Access Compliance Report Public Rights-of-Way (Curb Ramps)

Main Street: ROLLING RIDGE Cross Street: PINEHURST_ST Location: SW

ADA ID: RPRK211019135406 Ramp Type: Type 4 - Parallel Initial Pass/Fail: Fail Overall Compliance: No Severity Score: 30

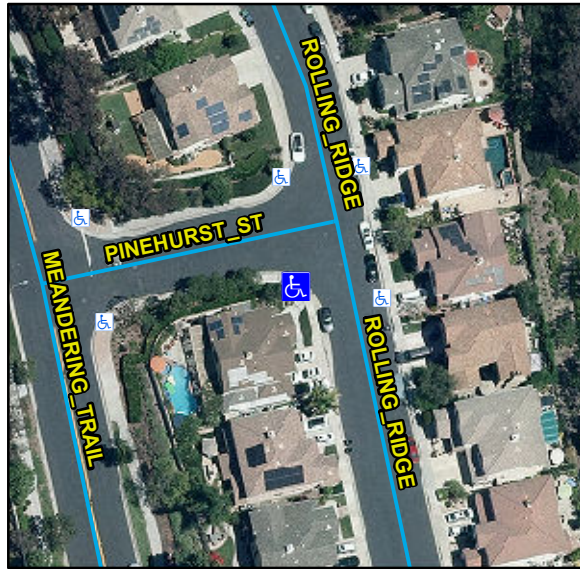
R304.2.2, R204.3, R304.5.3, R302.7.2, STD 1115

Compliance	Description	Data	Compliance	Description	Data
N/A	Ramp Length LT (in)	118	N/A	Ramp Length RT (in)	110
Yes	Ramp Width LT (in)	53	Yes	Ramp Width RT (in)	54
Yes	Ramp Run Slope LT (%)	1.1	Yes	Ramp Run Slope RT (%)	1.4
No	Ramp Cross Slope LT (%)	11.6	No	Ramp Cross Slope RT (%)	10.3
N/A	Landing Present	N/A	N/A	DWS Provided	N/A
N/A	Landing Length (in)	N/A	N/A	DWS Contrast	N/A
N/A	Landing Width (in)	N/A	N/A	DWS Length (in)	N/A
N/A	Landing Run Slope (%)	N/A	N/A	DWS Full Width	N/A
N/A	Landing Cross Slope (%)	N/A		DWS Offset Type	N/A
N/A	Landing Movement Obstructed?	N/A	N/A	DWS Offset Left (in)	N/A
	Landing Movement Type	N/A	N/A	DWS Offset Right (in)	N/A
N/A	Landing Shared	N/A			
N/A	Clear Space	Yes			
N/A	Clear Space To Crosswalk (in)	N/A			
N/A	Marked Crosswalk 1	No	N/A	Marked Crosswalk 2	No
	Crossing 1 Direction	E		Crossing 2 Direction	N
	Marked Crosswalk 1 Width (in)	N/A		Marked Crosswalk 2 Width (in)	N/A

N/A	Ramp Inside Crosswalk 1	N/A	N/A	Ramp Inside Crosswalk 2	N/A
	Crossing 1 Slope (%)	1.2		Crossing 2 Slope (%)	3.1
	Crossing 1 Cross Slope (%)	1.1		Crossing 2 Cross Slope (%)	2.2
N/A	Gutter Ponding	N/A	No	Curb Slope	9
No	Gutter Lip Height (in)	0.25		Road Run Slope (%)	0.5
N/A	Gutter Run Slope (%)	N/A		Road Cross Slope (%)	9.8
N/A	Gutter Cross Slope (%)	N/A	No	Perpendicular Joint Present	No
Yes	Overall Surface Condition	Acceptable			
	Cross Gutter Present?	No		Spandrel Present?	No
	Replace Cross Gutter?	N/A		Replace Spandrel?	N/A

Remove & Replace Curb Ramp With Two New Directional Ramps or Equivalent.
